**Technical Evaluation Report
of the
FTI-Lynchburg Appendix K LOCA Code, Rev. 5
BEACH Topical Report BAW-10166
Appendices H and I**

Technical Evaluation Report
FTI-Lynchburg Appendix K LOCA Code, Rev. 5
BEACH Topical Report BAW-10166
Appendices H and I

Comments on Framatome Responses to RAI's on Rod-to-Rod Radiation

Figure 1
FLECHT-SEASET Test
31504
Test Rod 8K

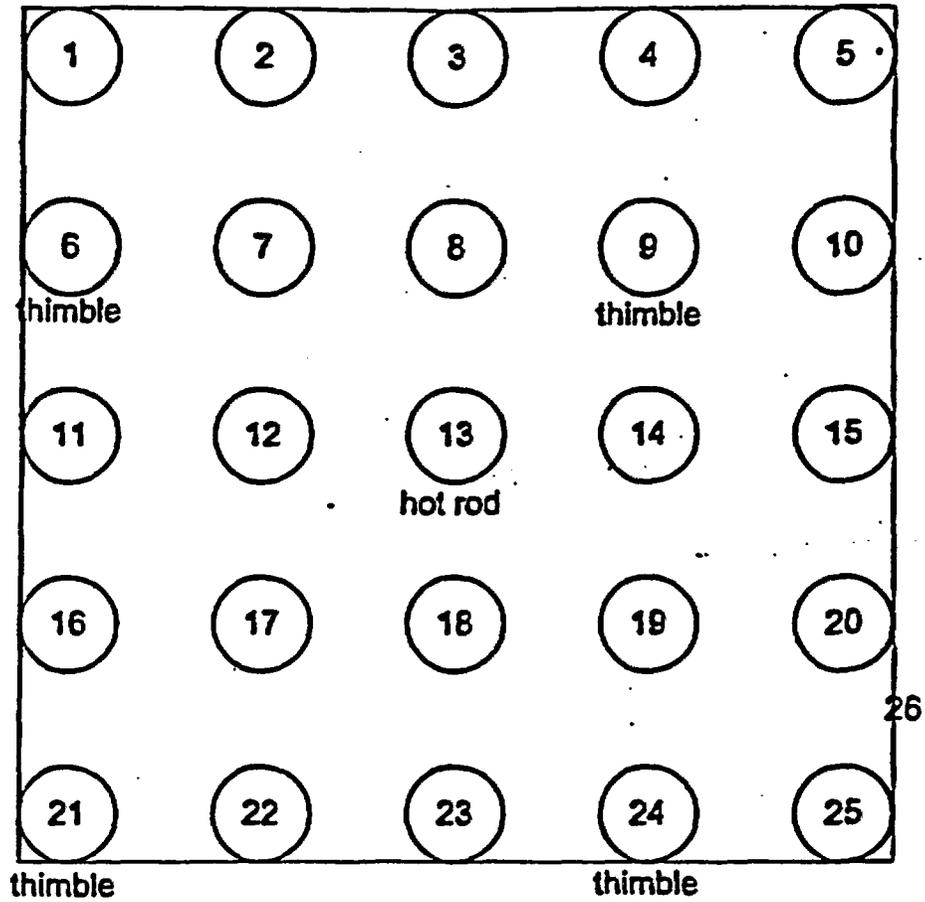
The rod-to-rod radiation in Tests 31504 and 31805 from the FLECHT-SEASET test series (NUREG/CR-2256) shows the rod-to-rod thermal radiation heat transfer to be 25 to 35% of the total heat transfer. The statement that radiation to unheated rods, thimbles, and adjacent rods is negligible is unjustified and incorrect. Framatome did not perform any thermal radiation calculations to support their contention that thermal radiation is non-negligible in the FLECHT tests.

A detailed multi-surface rod-to-rod radiation model was used to confirm the radiation heat transfer for the sample tests. Each of the tests was modeled as a 25-rod array (5x5) with the hot rod as the central rod and thimbles located in the appropriate positions. The following bounding conditions were assumed and the radiation heat transfer from the hot rod to the surrounding surfaces was calculated at the time of the PCT.

Case 1 (see Fig 1)

Hot rod location is rod 8K

Percent of total heat transfer 15.2%

Case 2 (see Fig 1)

Percent of total heat transfer 25.3%

- 7) Framatome needs to address the fact that rod-to-rod radiation is present in the FLECHT data and tuning a convective model to data that contains thermal radiation and convection is incorrect. The data should be corrected and the model re-tuned or thermal radiation should be accounted for in the BEACH dispersed flow film boiling model.
